HISTORIC AND DESIGN REVIEW COMMISSION

February 06, 2019

HDRC CASE NO: 2018-382
ADDRESS: 122 E HOUSTON ST
LEGAL DESCRIPTION: NCB 106 BLK LOT A-2
ZONING: D, H, RIO-3
CITY COUNCIL DIST.: 1
DISTRICT: Main/Military Plaza Historic District
APPLICANT: Ann McGlone
OWNER: Cabbage, Ltd
TYPE OF WORK: Modifications to existing sidewalk, installation of site elements, ADA improvements
APPLICATION RECEIVED: January 22, 2019
60-DAY REVIEW: March 25, 2019
REQUEST:

The applicant is requesting a Certificate of Appropriateness for approval to perform site modifications including the creation of an ADA accessible path adjacent to the existing storefront. The proposed modifications include the removal of the existing planters and trees and a new planter and tree will be installed. A raised seating area will also be installed. Existing pavers will be reused on site.

sheet
CIVIL PLAN

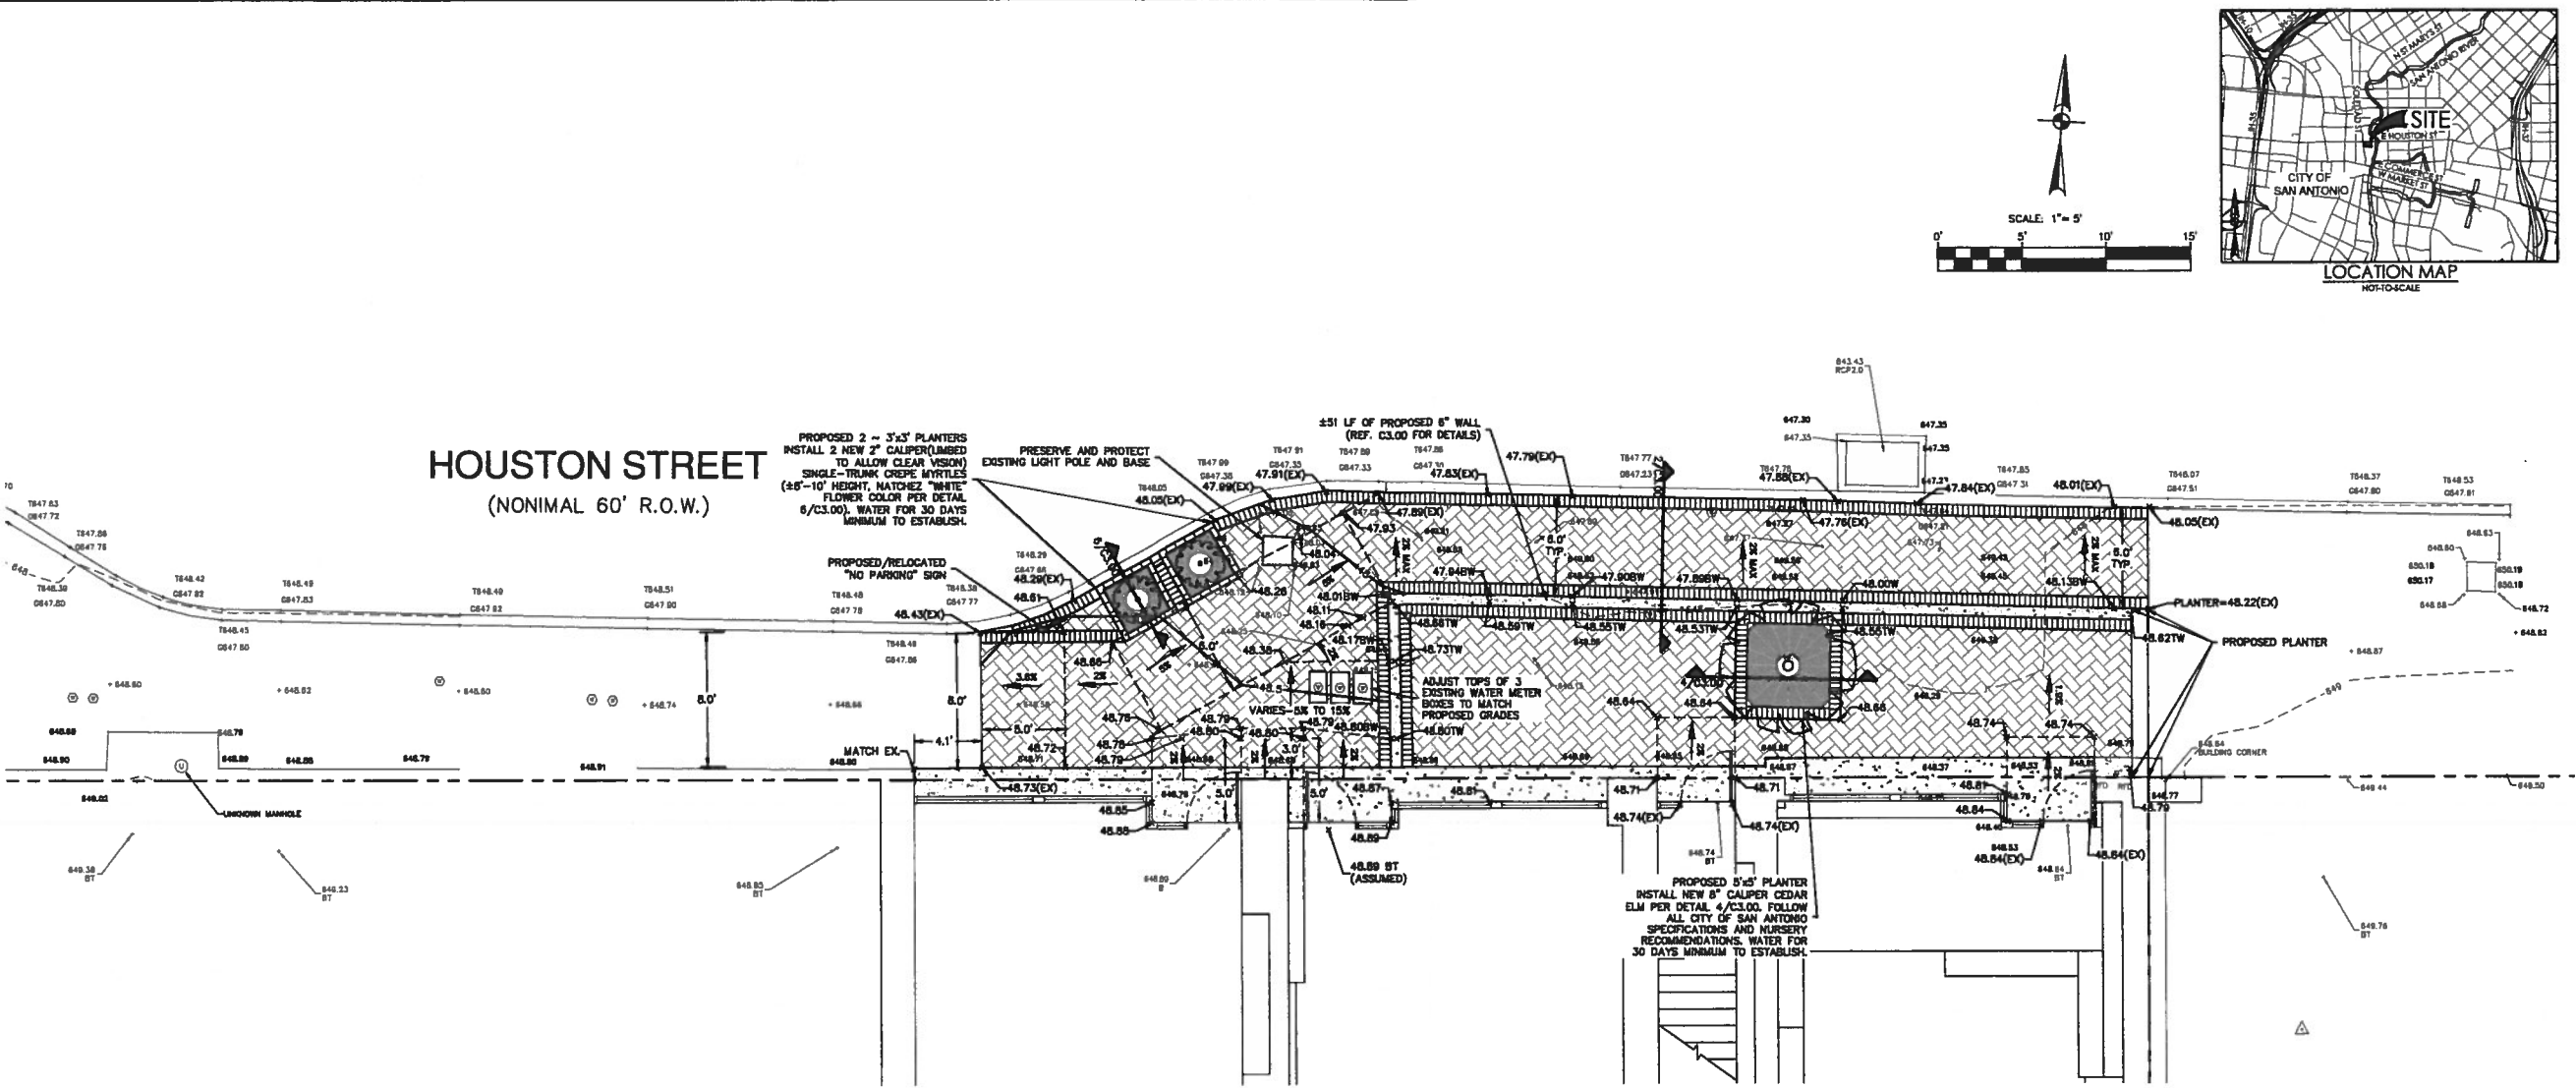
- c. **SITE MODIFICATIONS** – The applicant has proposed to modify the existing hardscaping to provide an ADA accessible entrance into the structure at 122 E Houston. The applicant has noted modifications to the site which include the removal of existing planters, modifications the grade, the creation of an outdoor seating area and a shifting of the pedestrian path. The pedestrian path will feature a minimum of six (6) feet at all locations.

Staff recommends approval as submitted based on findings a through d with the following stipulation:
